**10-14 Third Avenue, Blacktown
Development Application JRPP-16-03334**

We write on instruction from CIR Construction to provide additional information in response to an issue raised by the JRPP in its assessment of the subject application. The relevant issue is building separation and the concern, as expressed by the JRPP is:

Figure 1 – Typical floor plan (Level 4 shown)

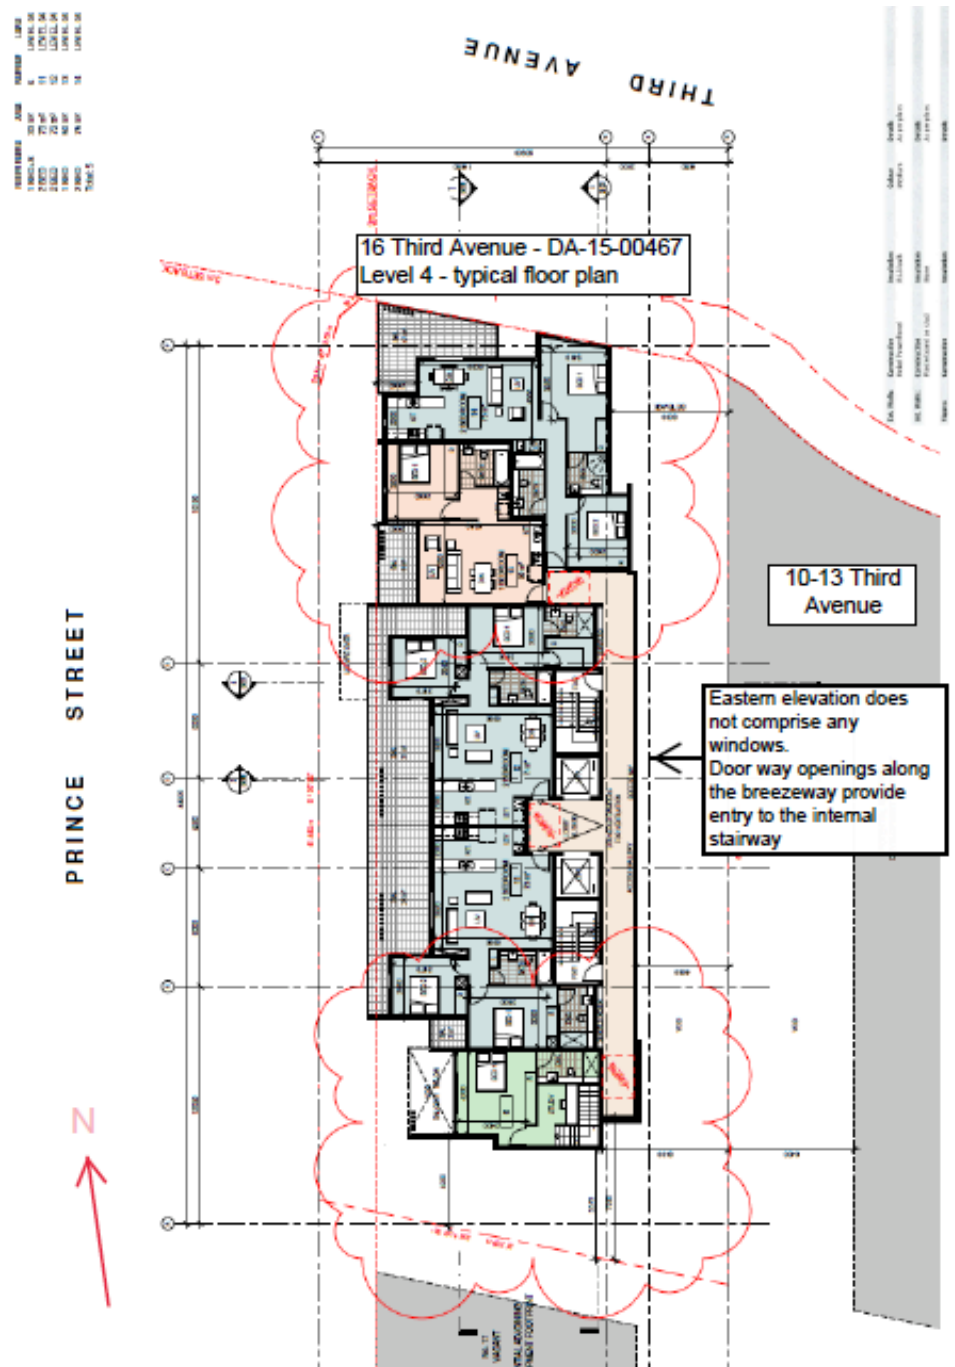
Whilst the McDonalds site to the east is possibly of sufficient size to compensate for reduced setbacks on that side, the same can't be said for the adjoining site to the west. Indeed, arguably that site may be isolated by this proposal due to its comparatively narrow width. Similarly, the non-compliant rear setback to the south must have some shadowing and possibly privacy impacts on the future development of those adjoining sites. Whilst the report refers to precedents for setback variations in this locality, the exact relationship to existing or approved developments on adjoining properties is not clear to the Panel.

Significantly, it is noted that the eastern elevation of the approved development - along the common boundary of No 16 and 10-14, does not contain any windows. Building articulation is achieved by provision of an external 'breezeway' or access walkway at each level of the building.

Figure 1 below shows the typical floor plan, with no windows present along the eastern elevation. Figure 2 shows the eastern elevation of the approved building. The doors along the 'breezeway' provide access into the internal stairway.
